Construction Division
Additions & Alteration Charges Approval Form

Company Name:	MRMLLP	Site	Gulmohar Residency
Name of the customer	Nilesh kumar-		
Villa/ Flat No.	C-404.

Details of Additions & Alterations

Flat No	404	Block no.	' C '
Flat Area	1660 sft	Type	Deluxe / Luxury
Buyer Name	Nilesh Kumar		
Phone No.	8790798388	Email

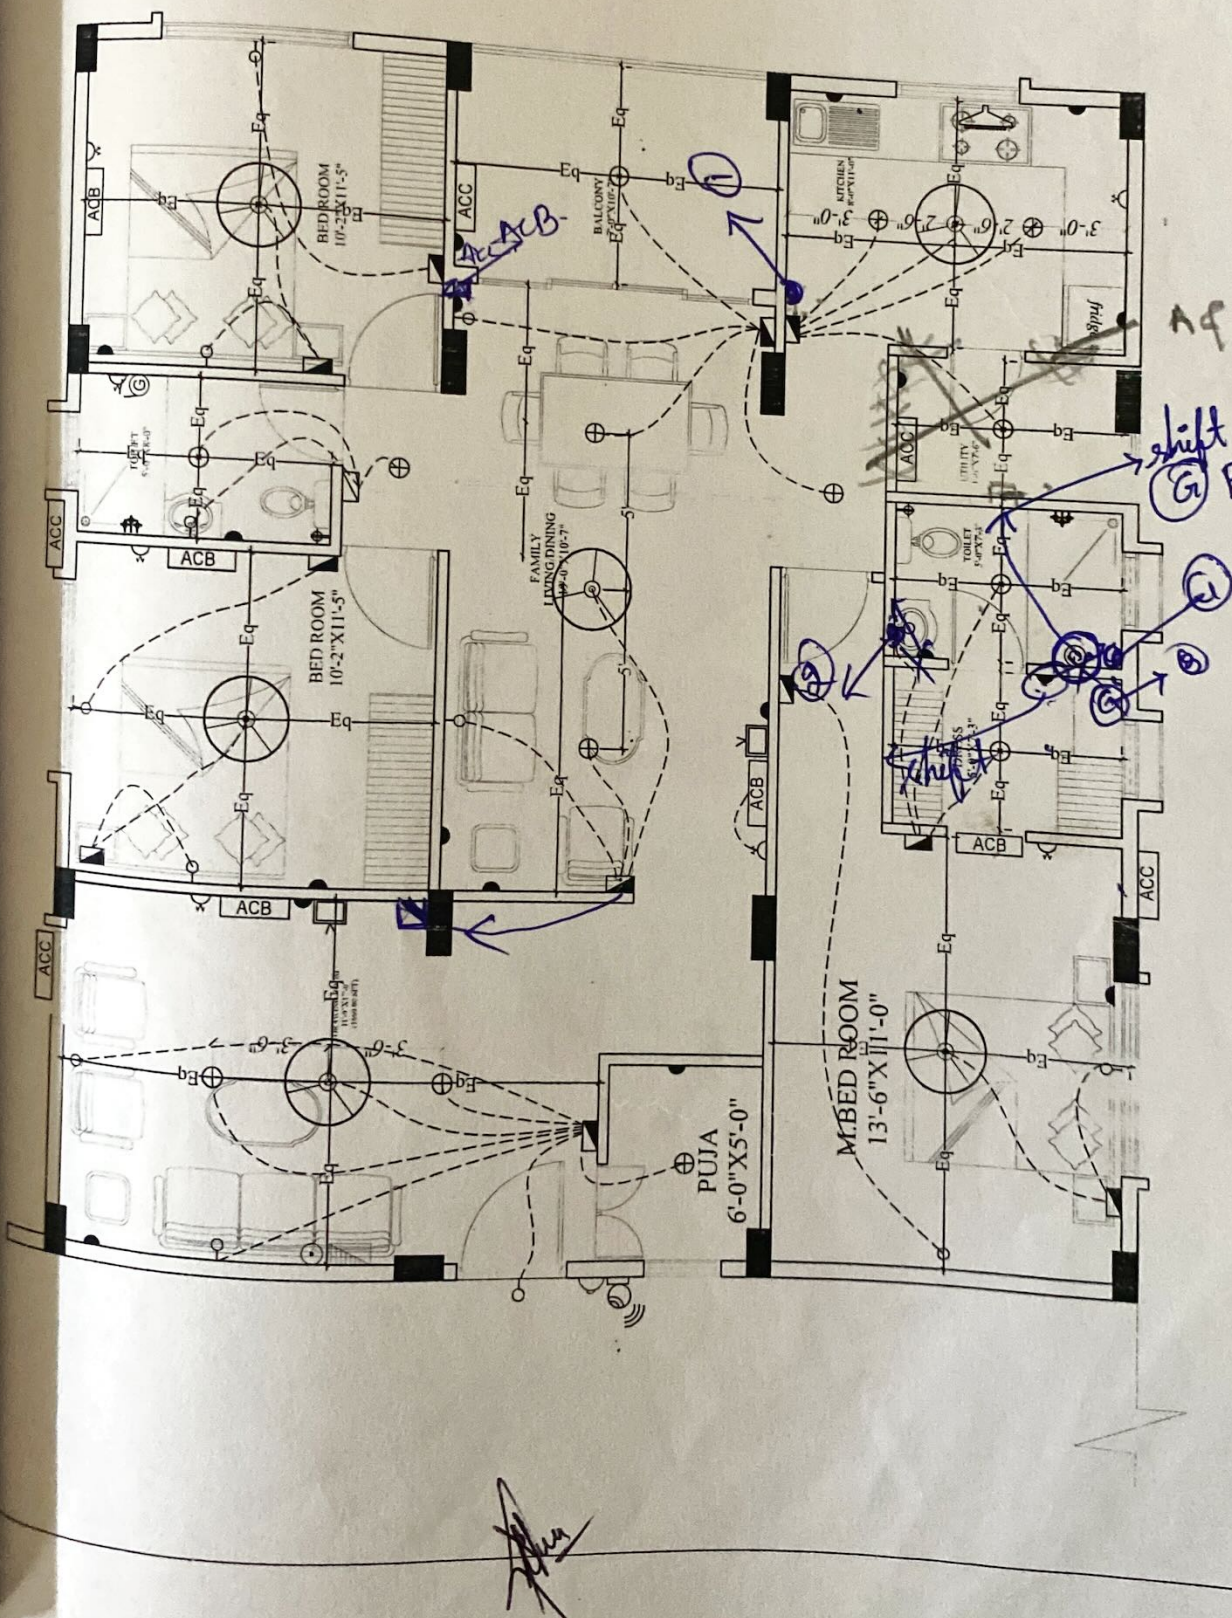
① Utility not required.

, Including kitchen left.

If possible make the opp. (or) adjacent.

② The wall in b/w the m. Bedroom & Din. not required.

③ M. Toilet - wall not required

BLOCK-ELECTRICAL PLAN -B2 TYPE-1660 sft	Description	Direction	Owners & Developers :	Date :	Promoted by
		N	Modi Reality Mallapur LLP	23.09.2020	Modi Properties Pvt Ltd
			Project Name & Phase :	Prepared By :	
			Gulmohar Residency	Approved By :	
				Scale :	NTS
					Phone: +91-40-66335551

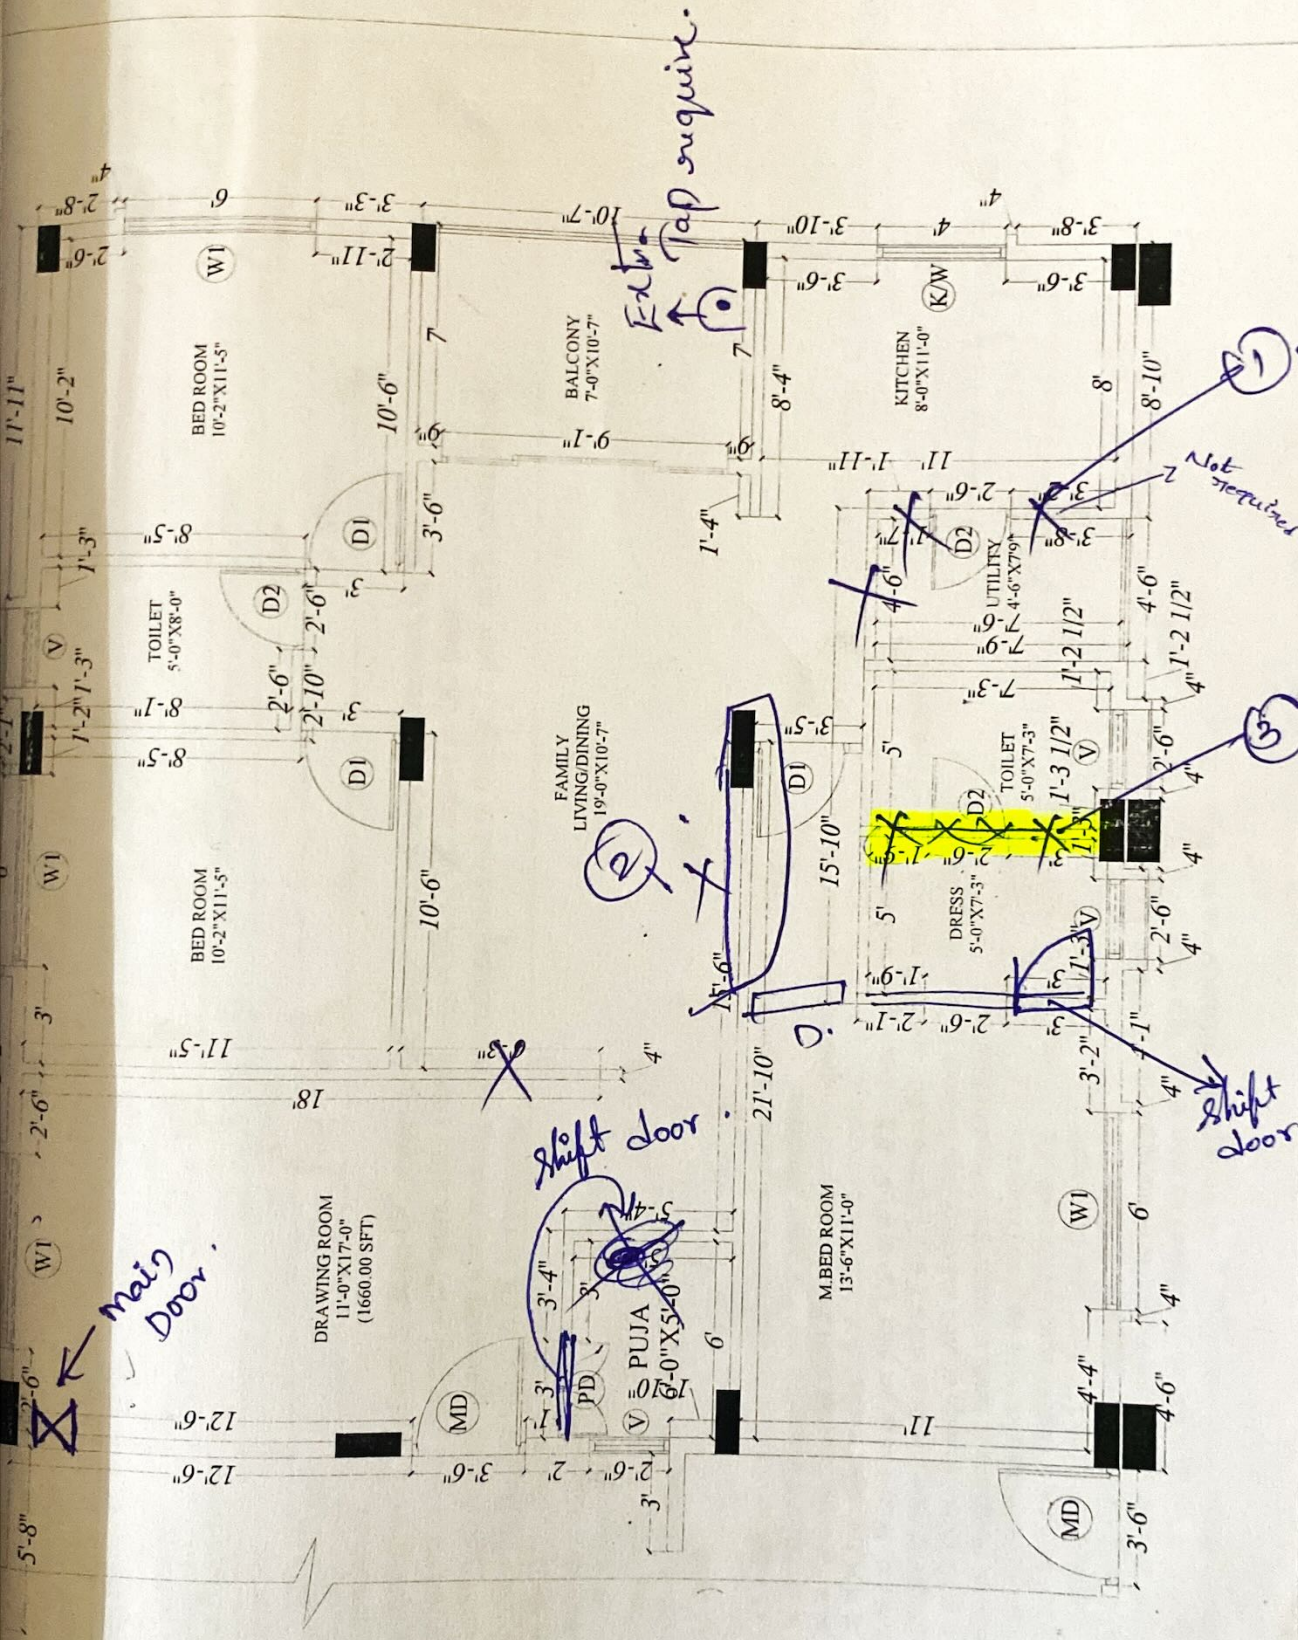
Changes in electrical points: (mark on plan)

- ① ~~M.T.~~ Extra fridge point
- ② S.A. socket down to the mirror place or up to the granite.
- ③ Gases to be shifted as plan marked.
- ④ The point to be shifted to opp. wall.
- ⑤ False Ceiling by Customer (Inform)
